ADDENDUM

Project: **Crestwood School District
Cherry Hill Baptist Church
Administration Relocation and Addition**

Date: **August 15, 2023**

Addendum Number: **#002**

3 SECTION
1" = 1'-0"

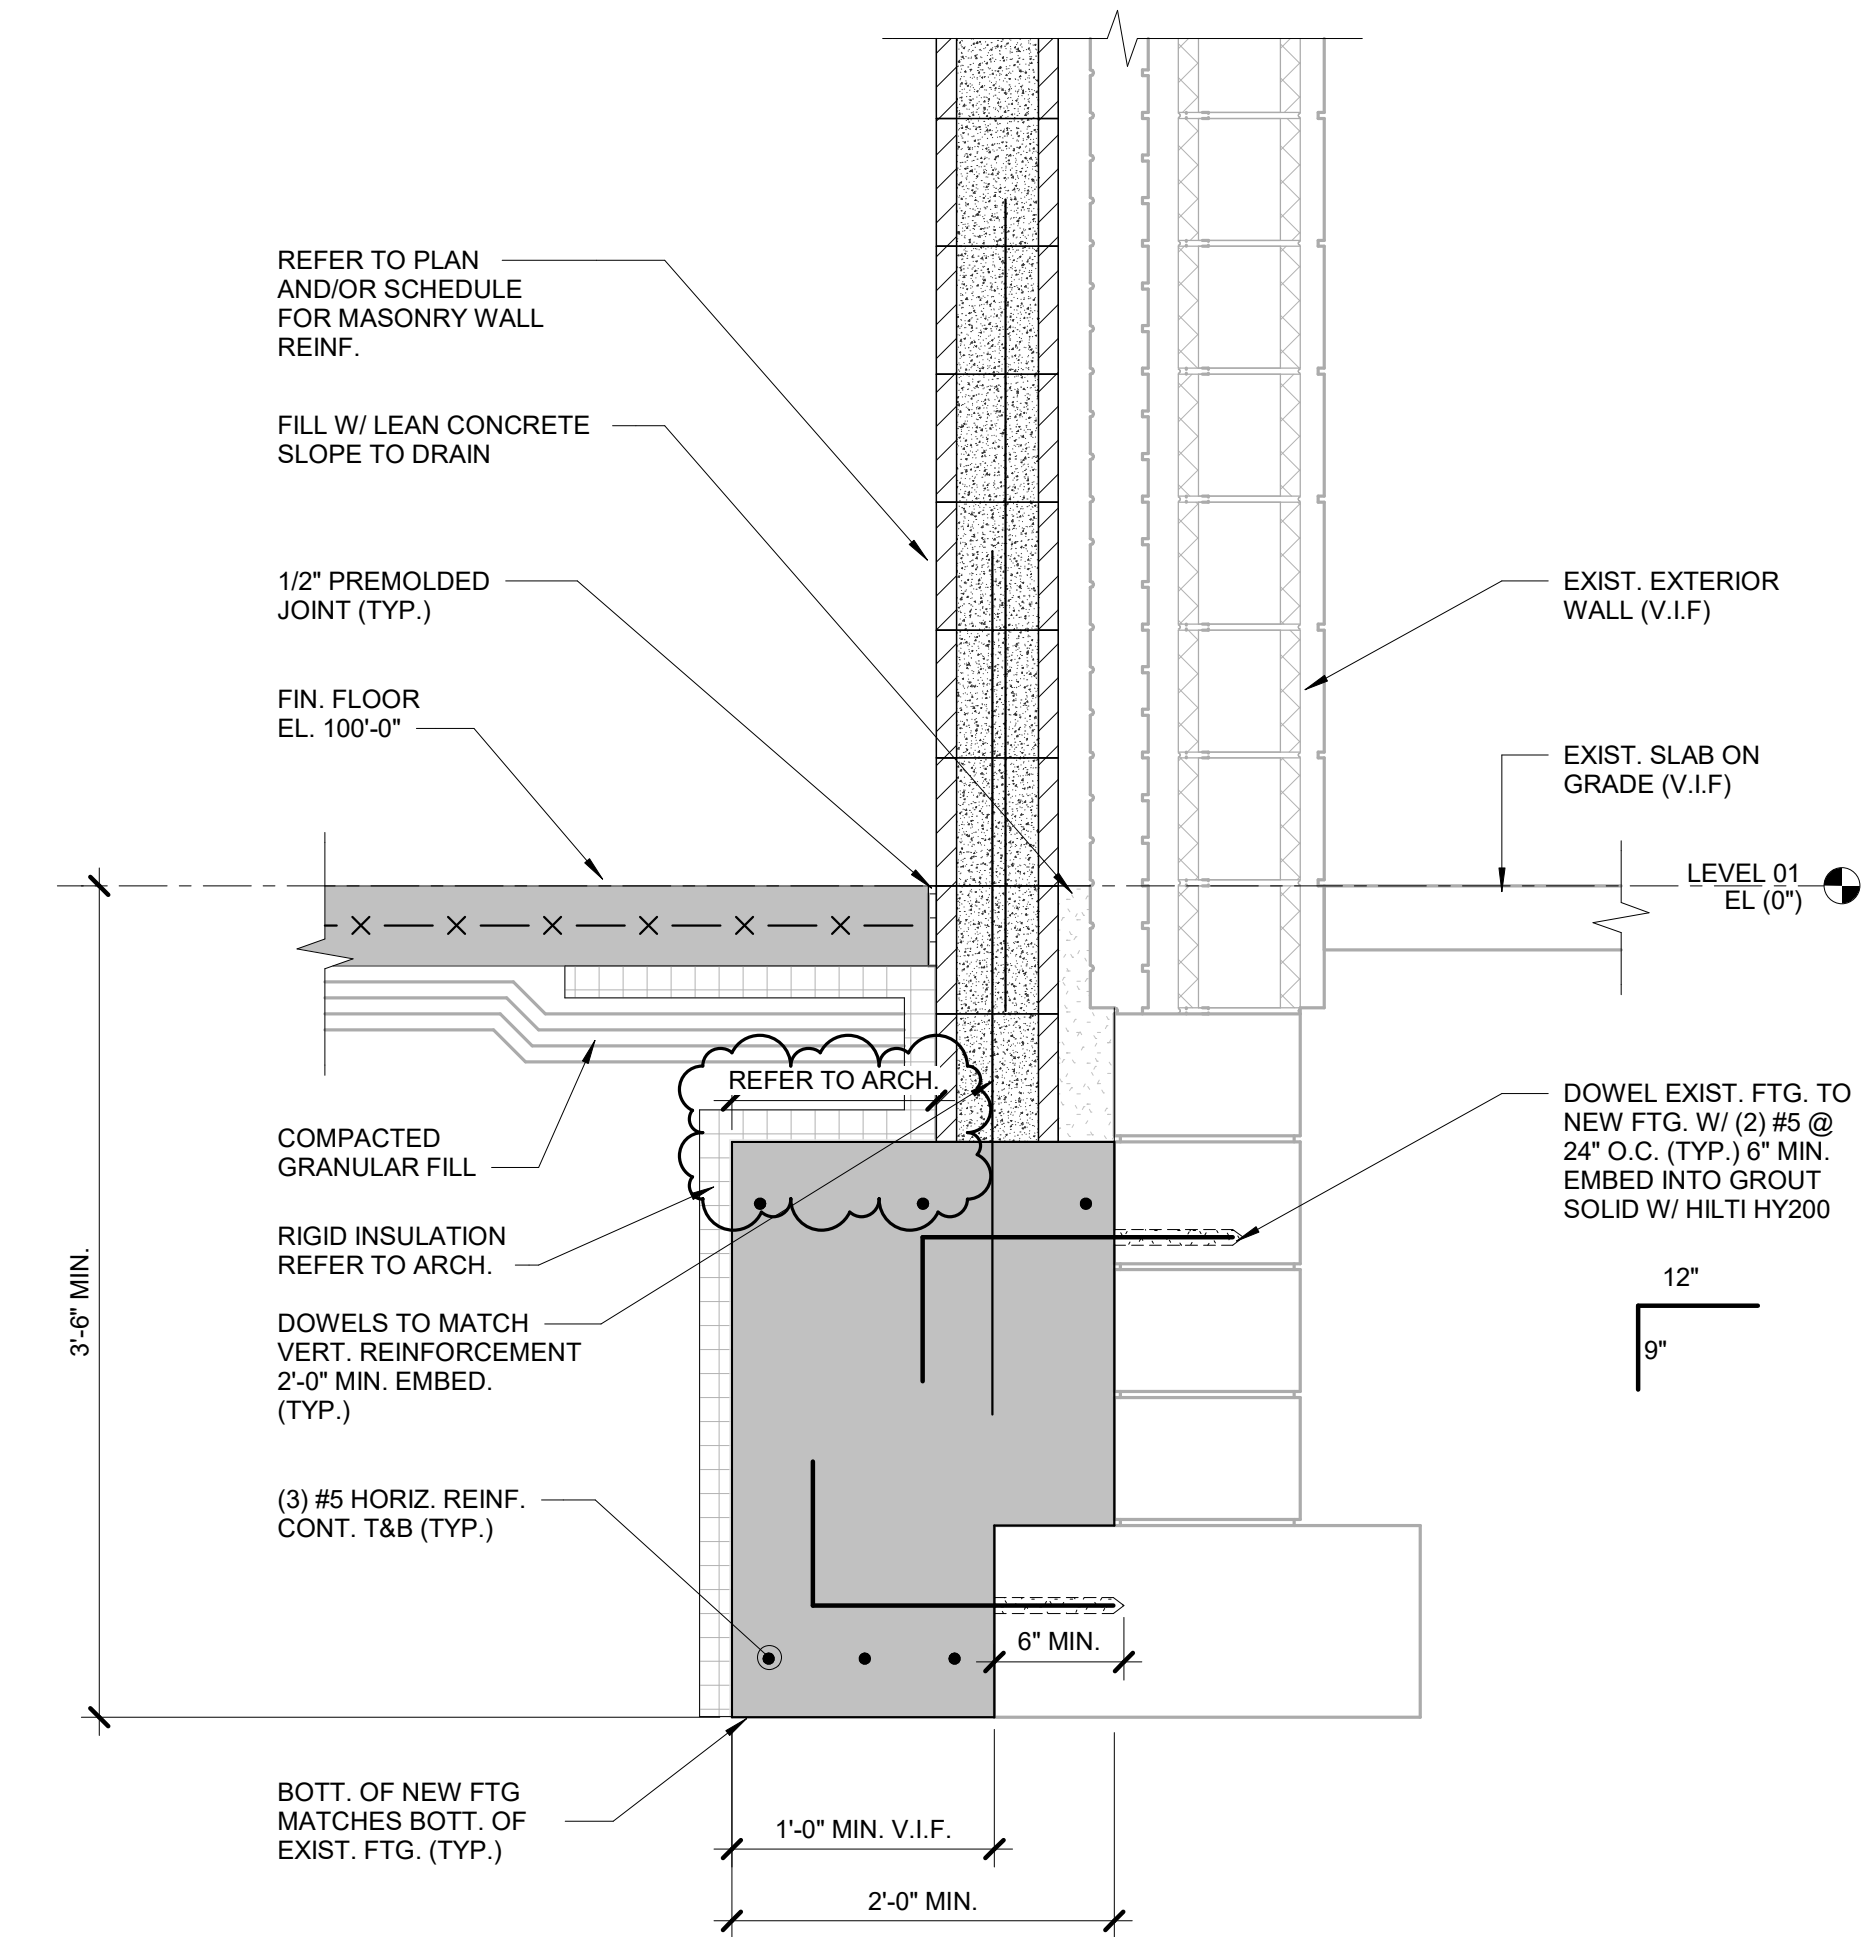
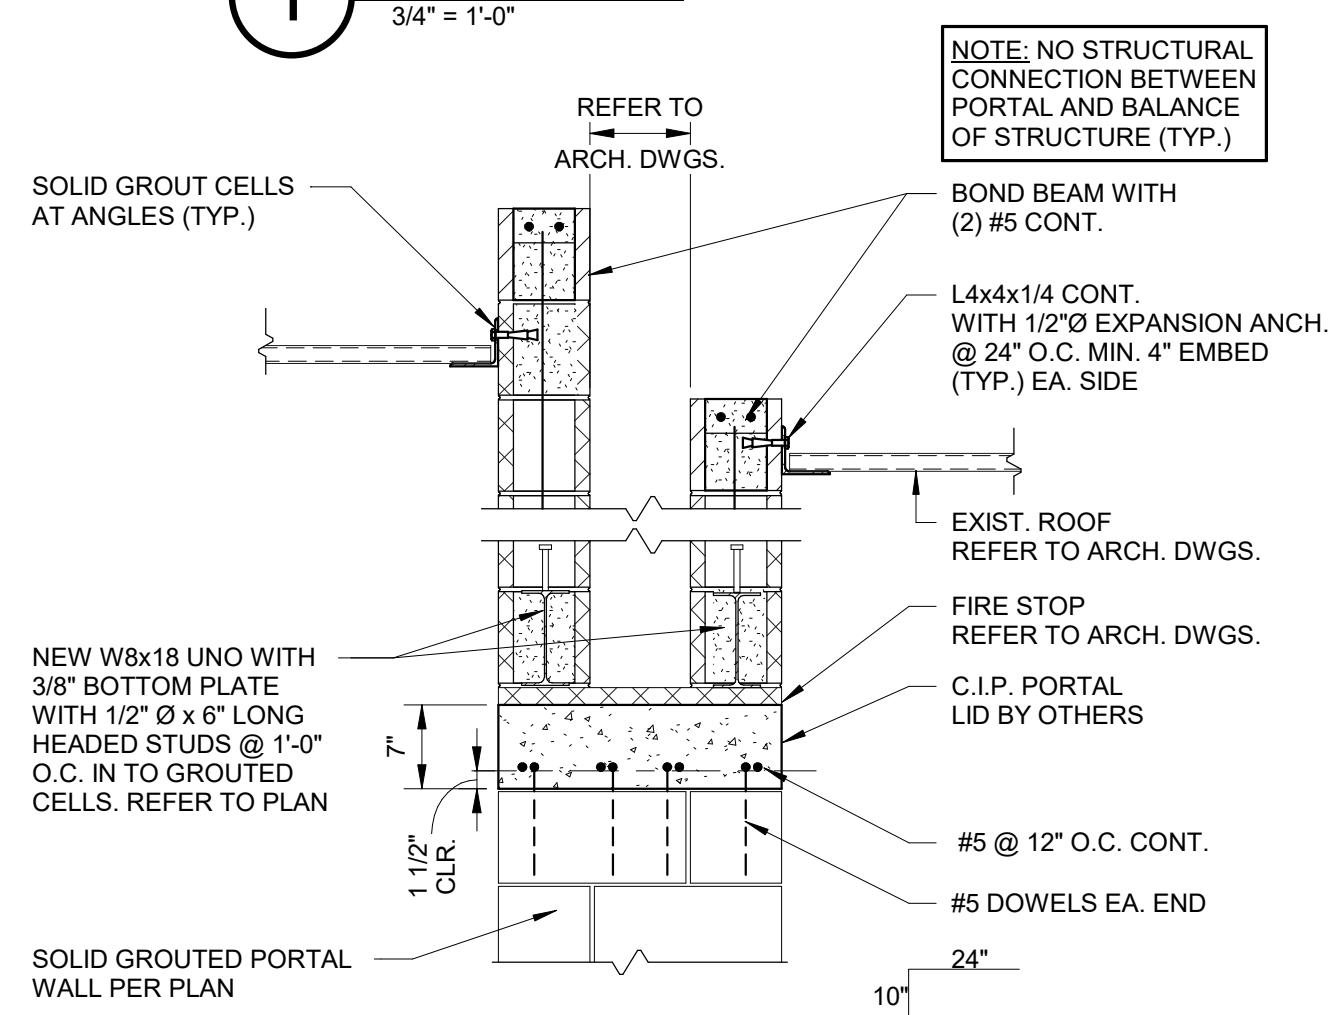
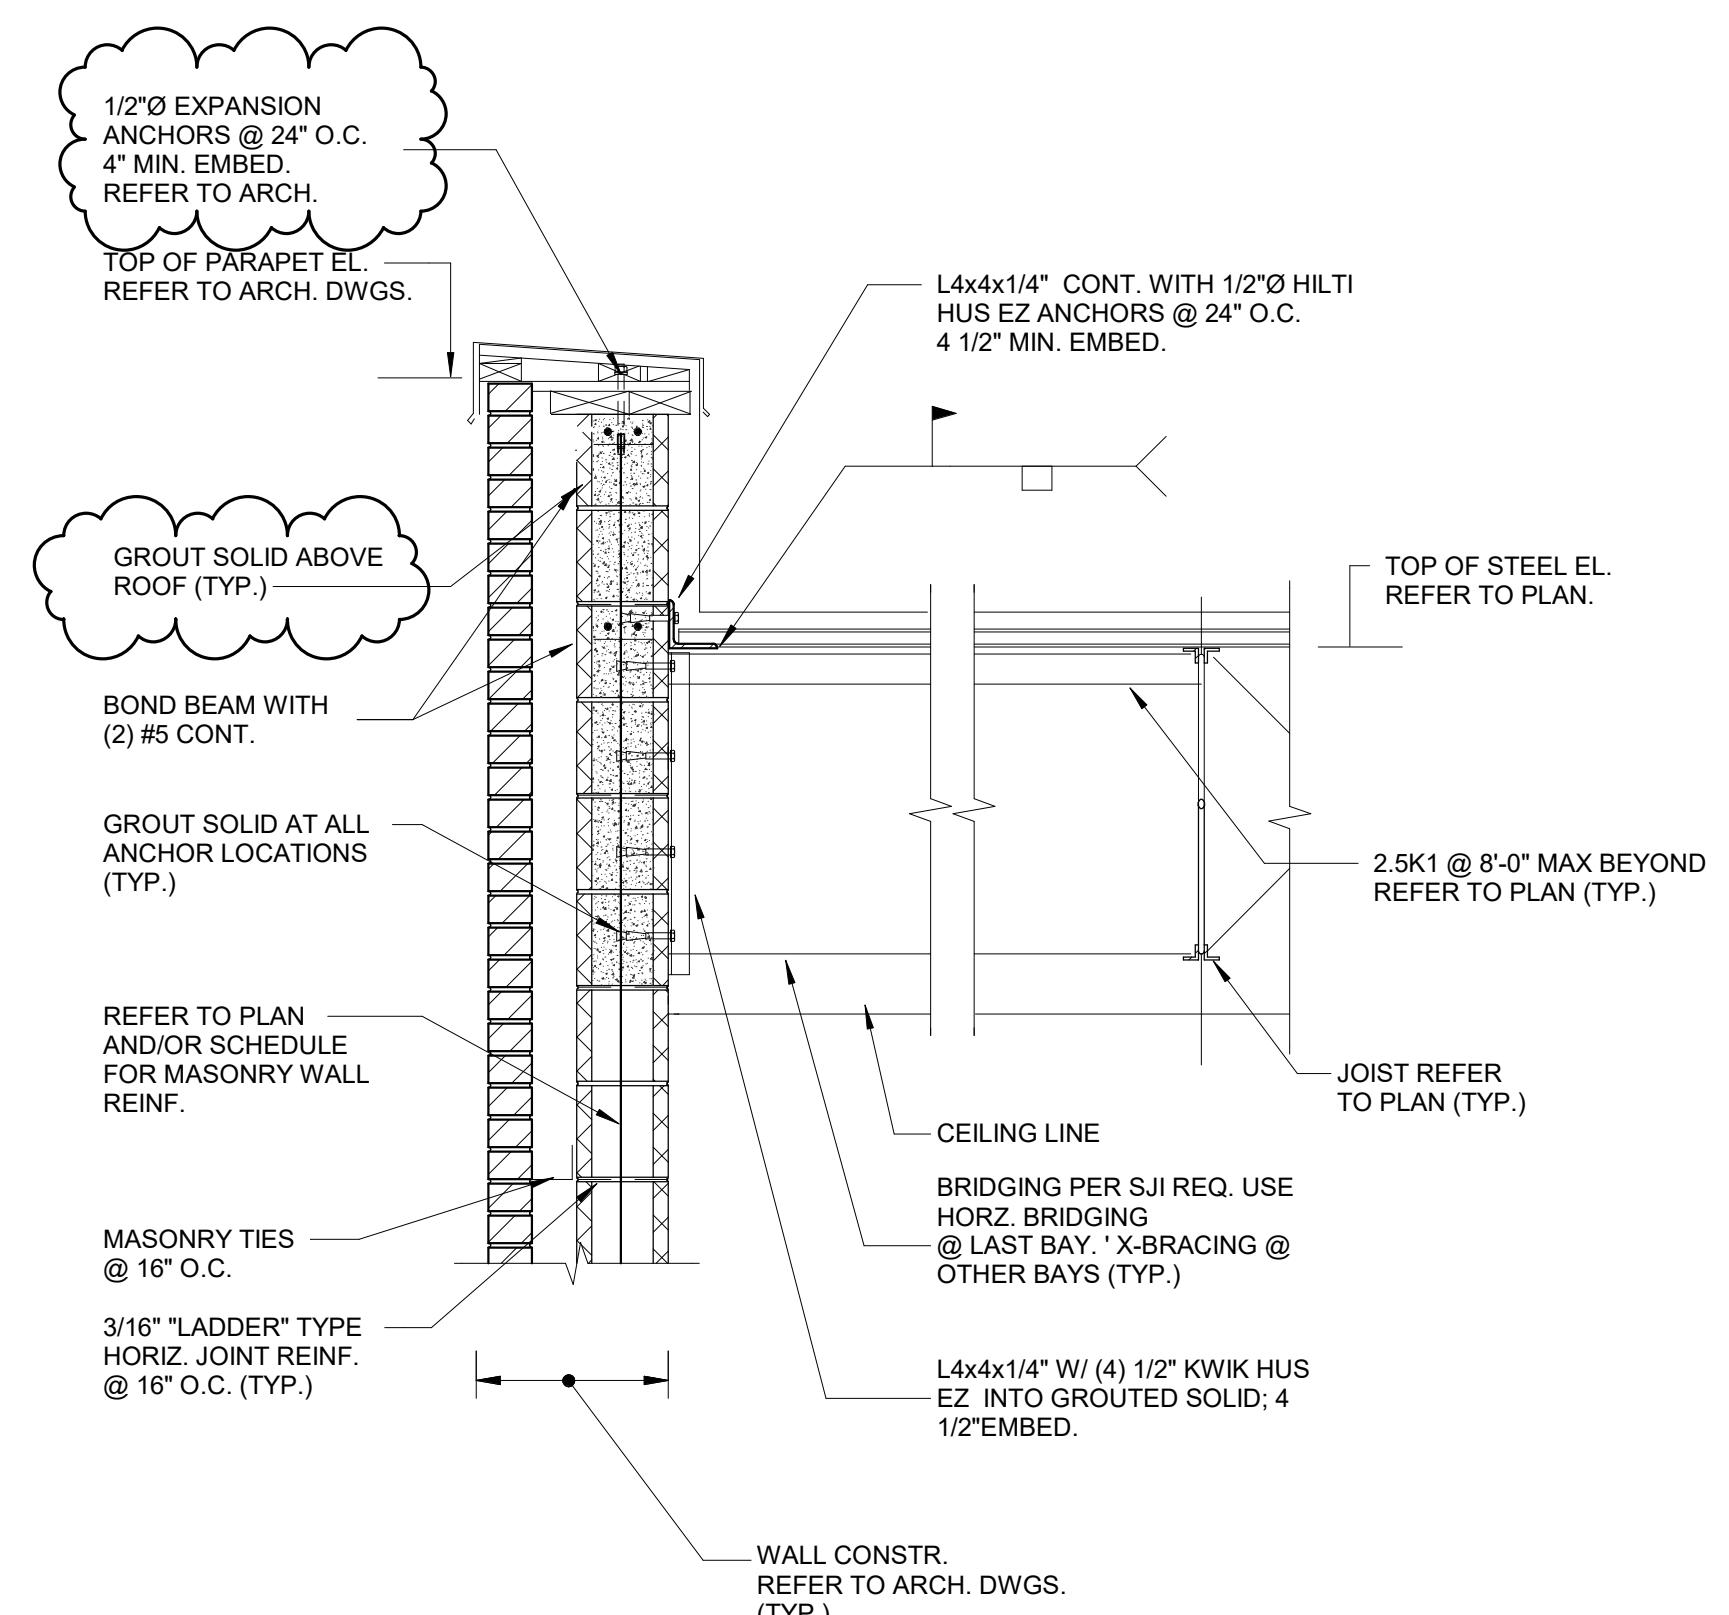
S6.01 - Typical Sheet Details

ADD: Sheet to drawing set.
